## CUSTOMER INFORMATION

### COMPLAINTS ON EVO ENGINE SERIES

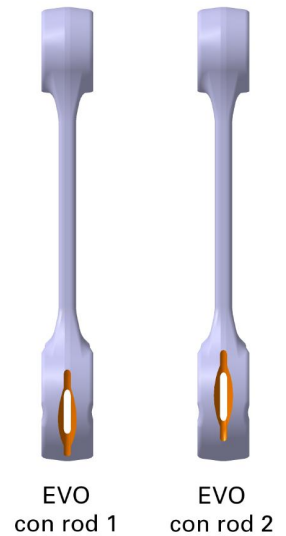
With the beginning of the racing season we have received complaints of failed evo 1 con rods.

These con rod failures have been analyzed and out of this the design of the evo 1 con rod has been slightly modified (= evo 2 con rod). This modification has significantly improved the durability of the con rod regarding the failures occurred on the market with evo 1 con rods.

As of following engine serial numbers the new evo 2 con rod is fitted as original equipment.

8398340 (125 Micro MAX evo, 125 Junior MAX evo, 125 MAX evo)

8382455 (125 MAX DD2 evo)

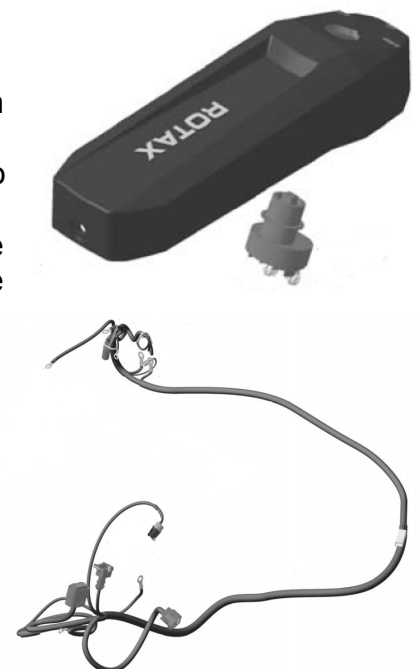
The claimed OFF/ON/START switches have failed due to an internal contact failure.

The technical design of the internal contact has been modified to ensure a faultless function.

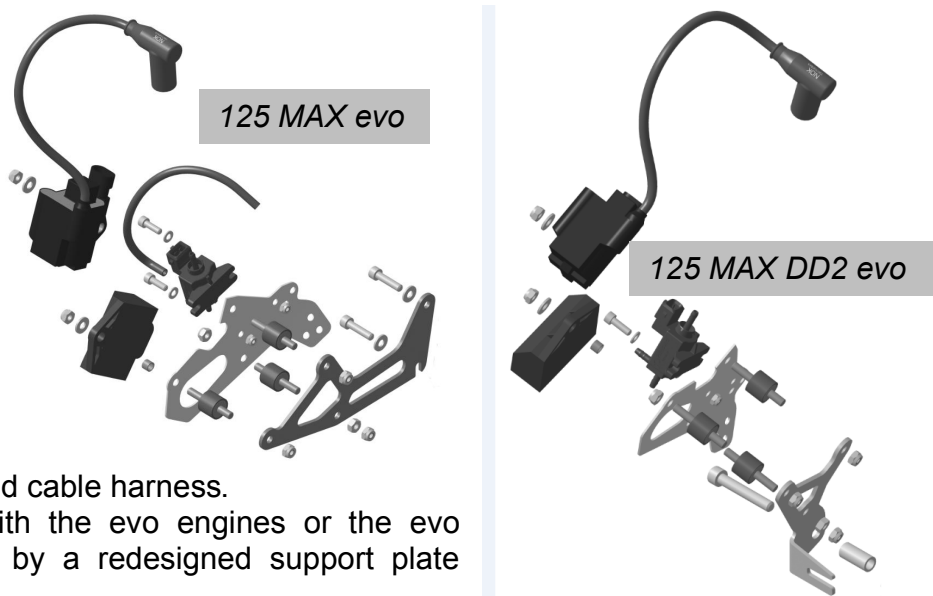
A lower vibration level of the electrical components (ECU, ignition coil, magnet valve) has a significant impact on the durability of the cable harness.

To minimize the vibration level of the electrical components BRP-Rotax will initiate an exchange campaign for the support plate which carries the ECU, ignition coil and magnet valve in combination with the improved cable harness.

The support plate supplied with the evo engines or the evo upgrade kits will be replaced by a redesigned support plate system (see illustrations).
